PUBLIC SCOPING REPORT

Environmental Impact Statement Desert Quartzite Solar Project

Bureau of Land Management

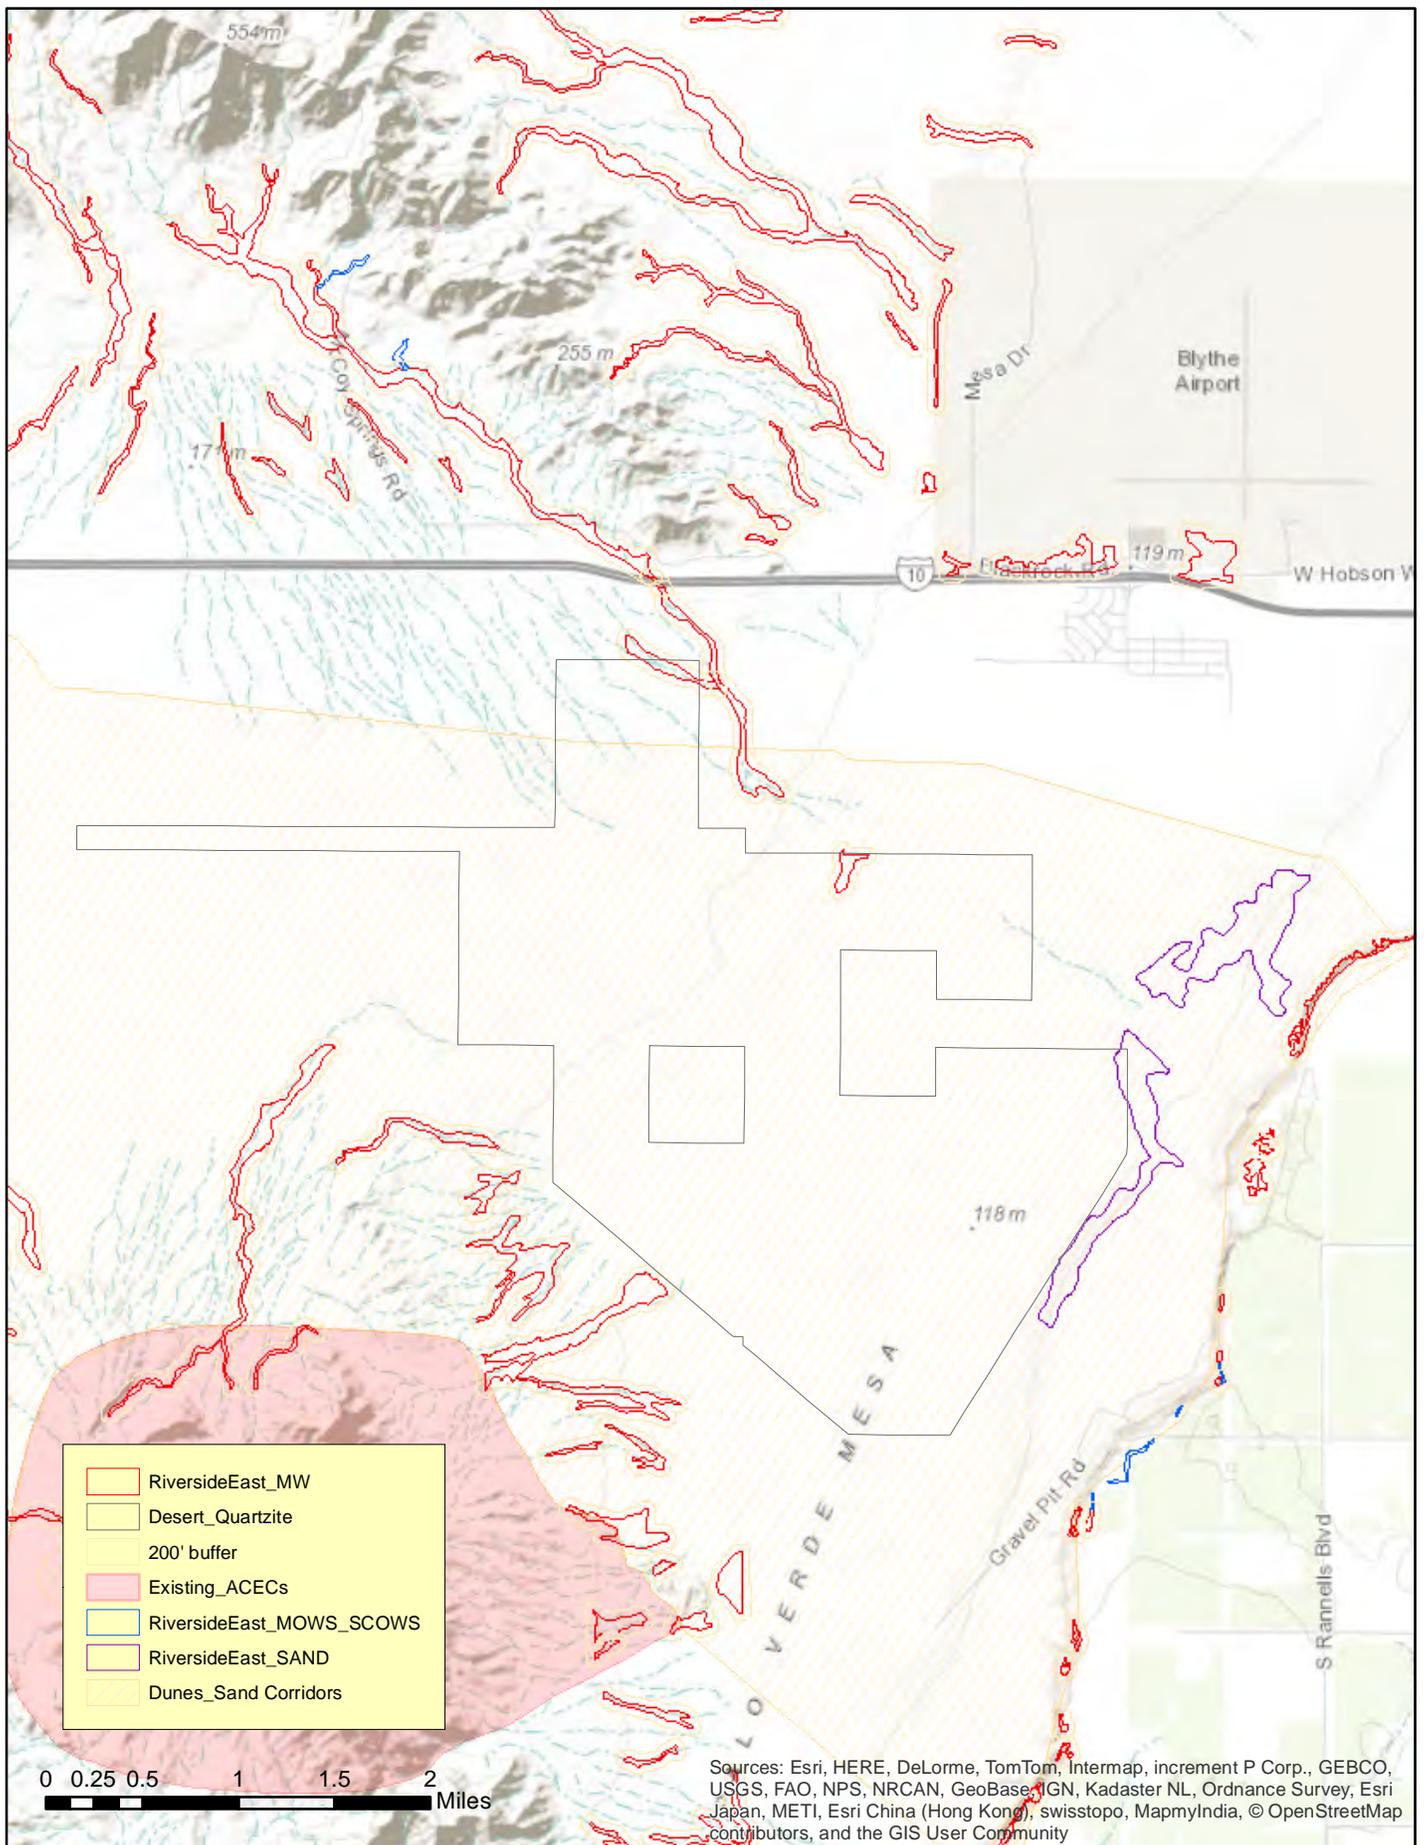
These stands of rare vegetation should be avoided. Figure 1 illustrates 2013 DRECP Vegetation Map information related to the proposed project site.

Figure 2. Proposed project site relative to Chuckwalla Valley sand transport corridor.

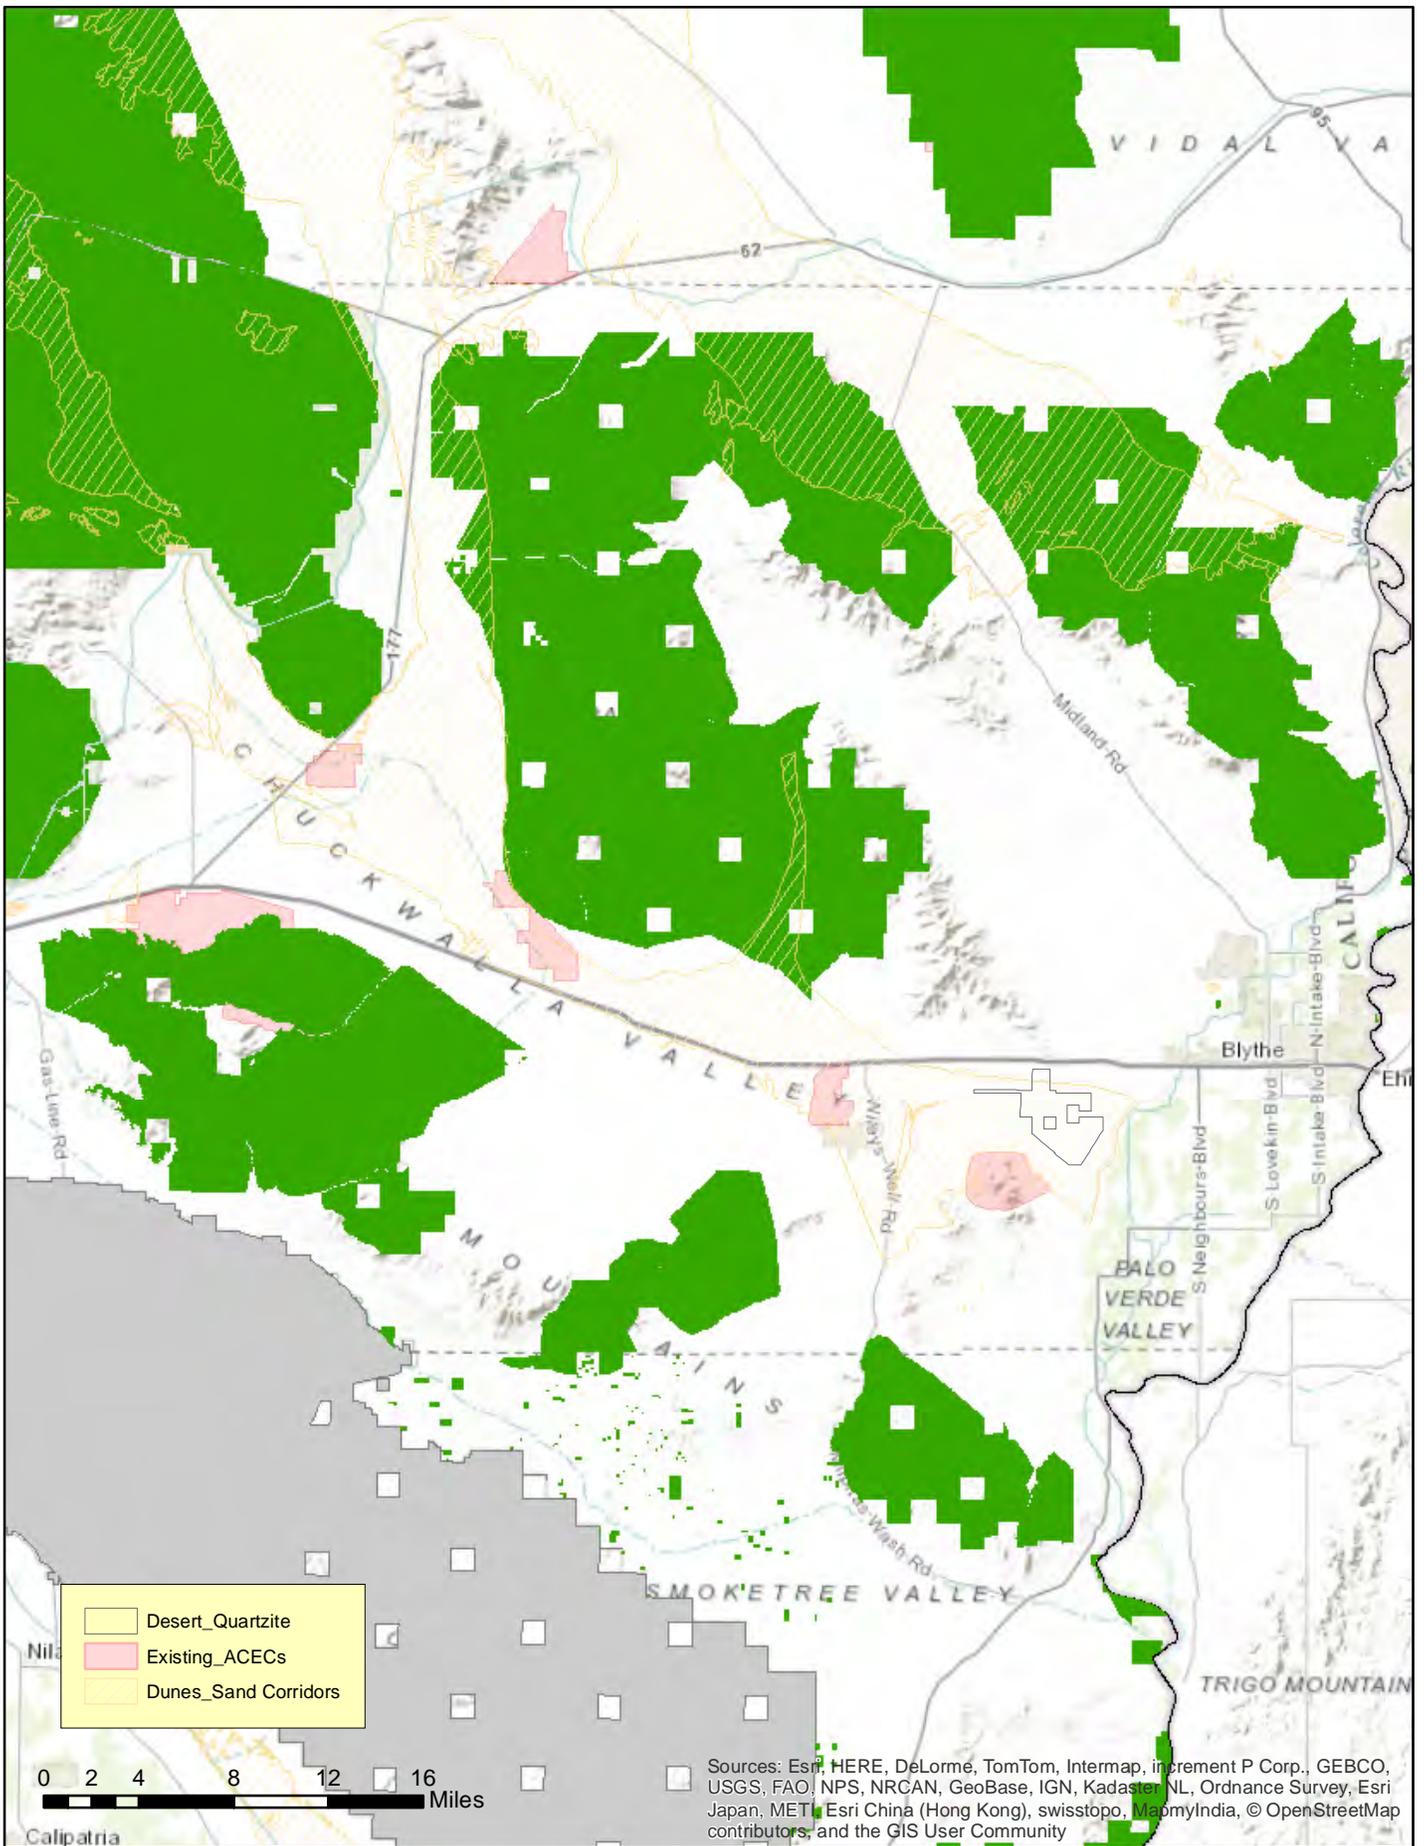
3. Proposed project is within the terminal end of sand transport corridor. Figure 2 illustrates the proposed project area in relation to the Chuckwalla Valley's sand transport corridor. Many desert sensitive species of plants and animals are dependent upon this natural feature. The DRECP's Alternative 3 proposed a Development Focus Area design that would avoid impacts within this ecologically important sand transport corridor. The proposed project site would not have conformed to DRECP Alternative 3's conservation goals (see Figure 3). The DEIS must assess how the proposed project site would avoid and/or mitigate for impacts to plant and animal communities dependent on the sand transport corridor.
